2004 - 2009 Cadillac XLR: Service Bulletin: #01-07-30-032E: Transmission Oil Leaking From Transmission Vent

#01-07-30-032E: Transmission Oil Leaking From Transmission Vent (Replace Transmission Case Cover (Channel Plate) Gasket) - (Sep 29, 2008)

Models: 1997-2009 GM Passenger Cars
and Light Duty Trucks
(including Saturn)

with Hydra-Matic 4T65-E
Automatic Transmission
(RPOs MN3, MN7, M15,
M76)

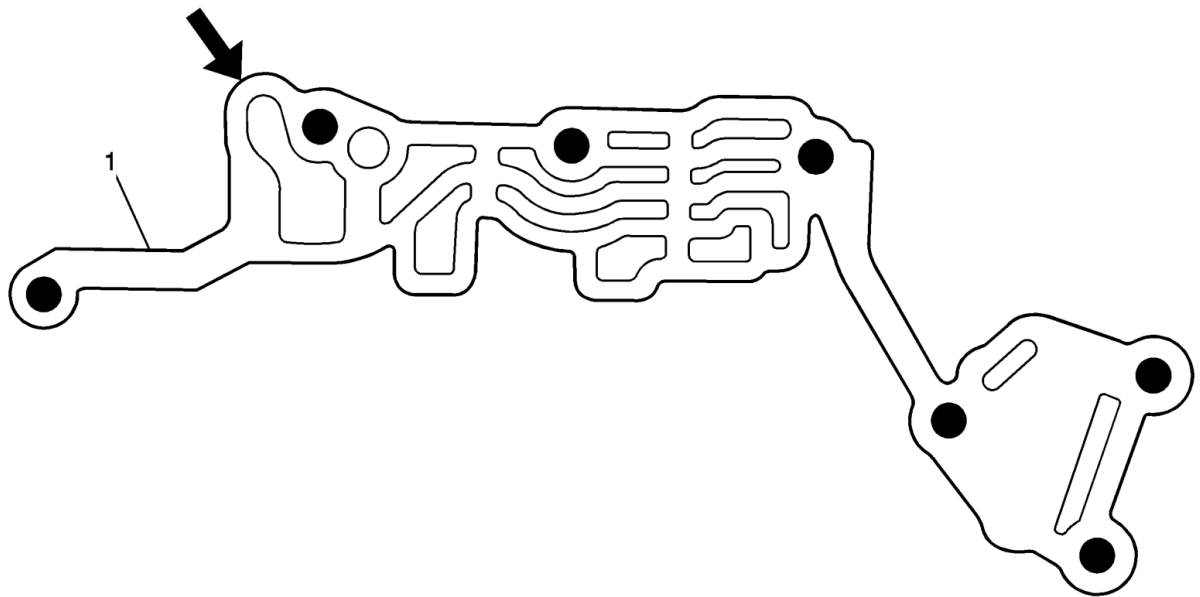
Visual inspection of the upper gasket (1) will reveal damage at the referenced area.

To correct this condition, replace the case cover (channel plate) gaskets (429 and 430). Refer to Unit Repair publication in SI of the appropriate vehicle being serviced.
